**SOIL/SITE EVALUATION  
 for ON-SITE WASTEWATER SYSTEM**

Proposed Facility:

Show profile locations and other site features (dimensions, reference or benchmark, and North).

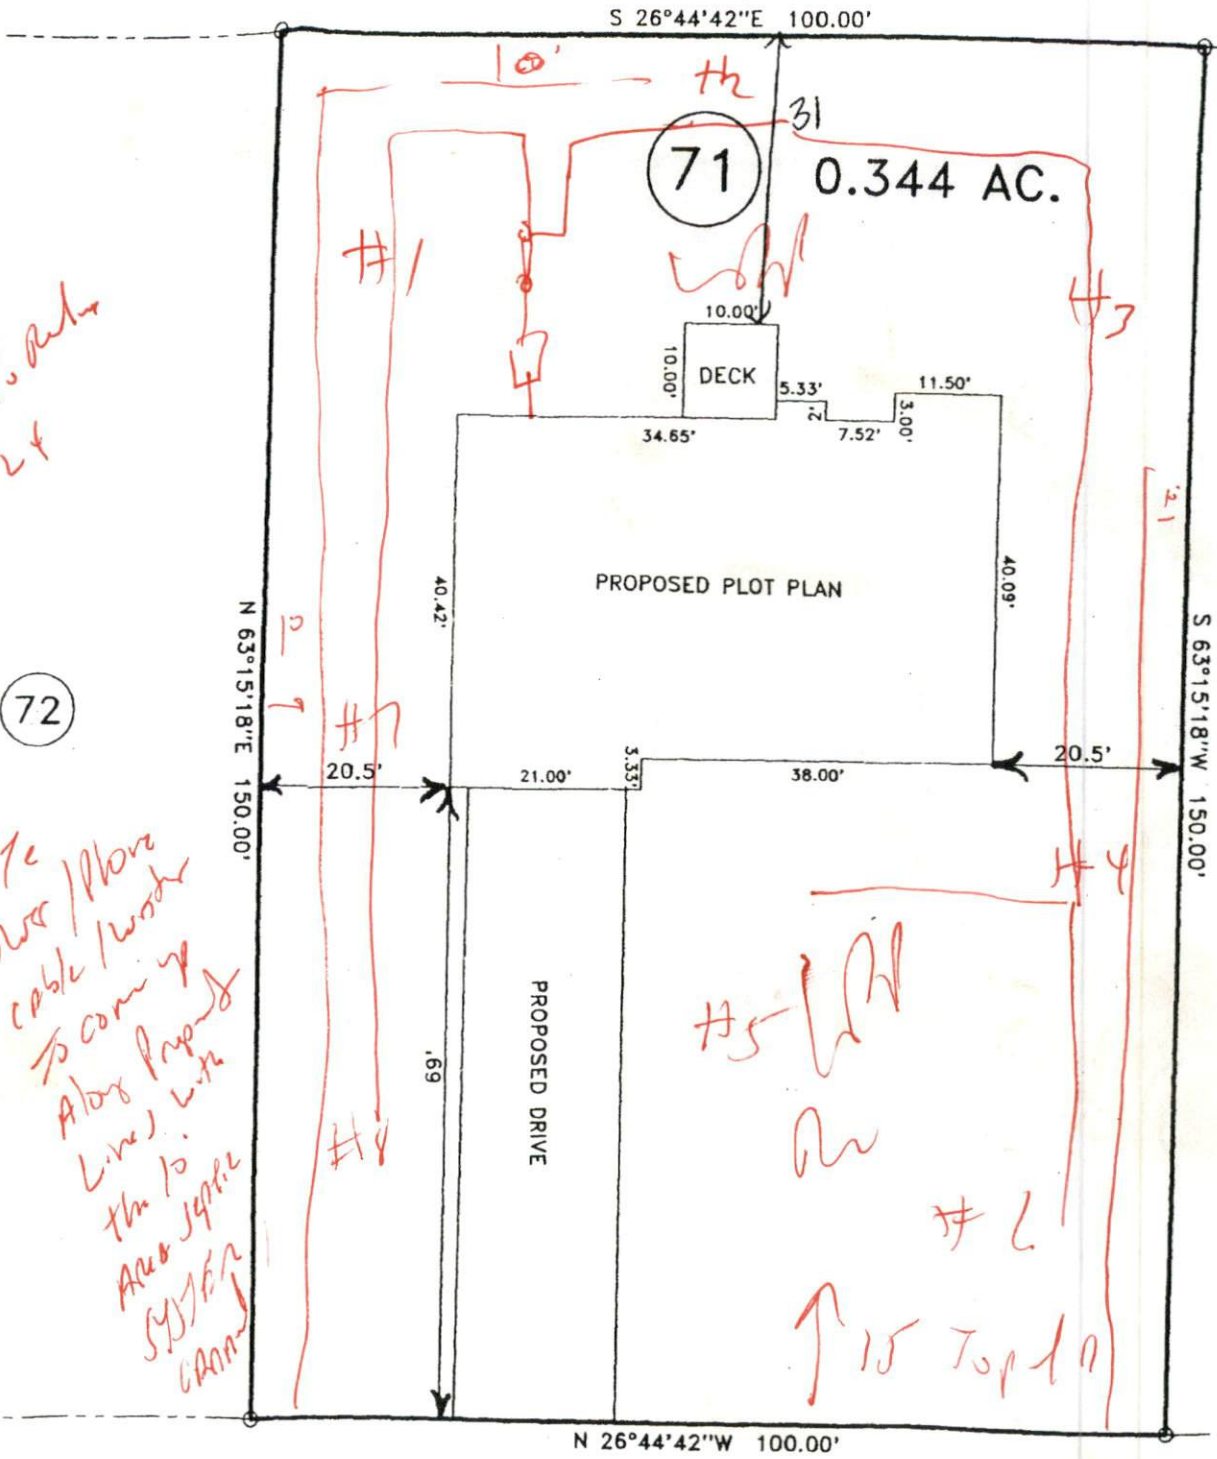
Note  
Power / Phone  
cable / water  
to come up  
Along proposed  
lines with  
the 10  
Area 14982  
SYSTEM  
CANN
